# Rezoning Transportation Analysis

Petition Number: 2020-161

General Location Identifier: Tax ID 03327114

Date	Description
12-28-2020	First Review (EL)
1-21-2021	Second Review (EL)
02-24-2021	Third (LJ)

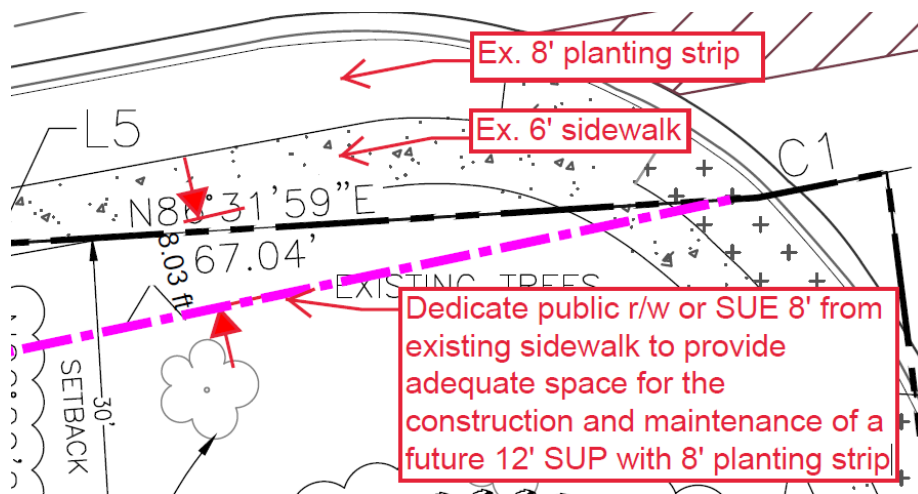
7. ~~Technical Clarification (site plan dated 1-10-21) Revise the site plan and conditional note (Section Transportation.E.) to dedicate public right of way or a sidewalk utility easement at the location below.~~
